Interactive comment on “Regional analysis of groundwater nitrate concentrations and trends in Denmark in regard to agricultural influence” by B. Hansen et al.

Author response to Anonymous Referee #2

Fig. 2.

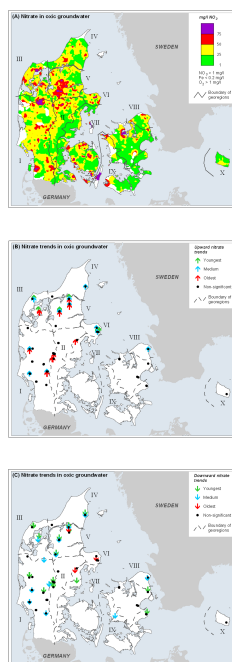
Temporal effects in map (special distribution)? The purpose of using all available nitrate data in constructing figure 2 is to show that nitrate has been found in groundwater almost everywhere in Denmark. Most of the data is based on groundwater sampling after 1990, so the geographic distribution is believed to be due to mainly spacial and not sampling time differences across the country. The different types of data used for constructing the figures were not clear in the first submission of the paper. The different groundwater nitrate data used in the statistical analyses of nitrate in Danish groundwater are now been elaborated by including a table (table 1) and some text corrections has also been made in order to make the data analyses more clear.

Figure 2 a-c: The 3 figures in Fig.2 a-c has been enlarged and are now in colours in

order to make them more readable.

Fig. 3.

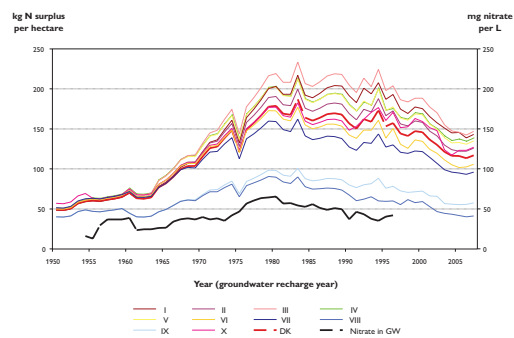
Figure 3: We think it is important to show all the lines in Fig. 3. Therefore the figure is now in colours in order to be able to recognize all the lines.
